Re: **DRB24-1026** – Narrative Responses to First Submittal
Comments

Draft Notice: DRB24-1026 94 Palm Ave: An application has been filed requesting Design Review Approval for the construction a new two-story residence with an understory level, including one or more waivers, to replace an existing residence.

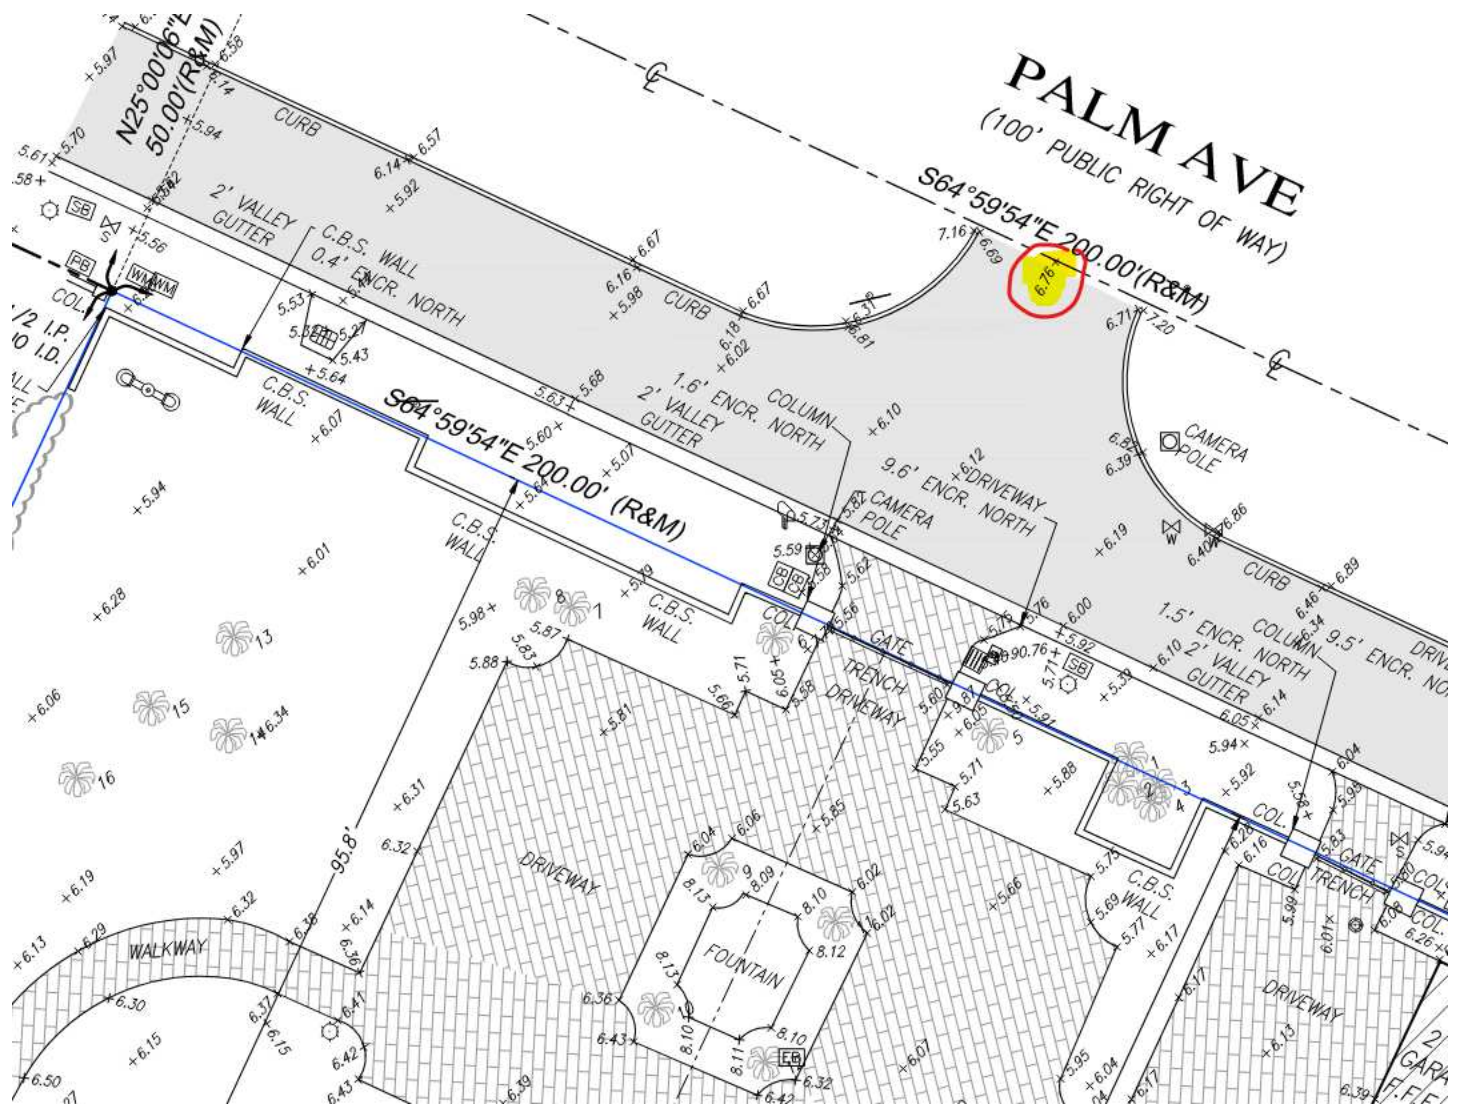
Would you consider the highlighted number below: 6.76' as the crown of road?

The crown of the road will be on the opposite side of the lane closest to your property. Use an average of 3 points in your calculations.
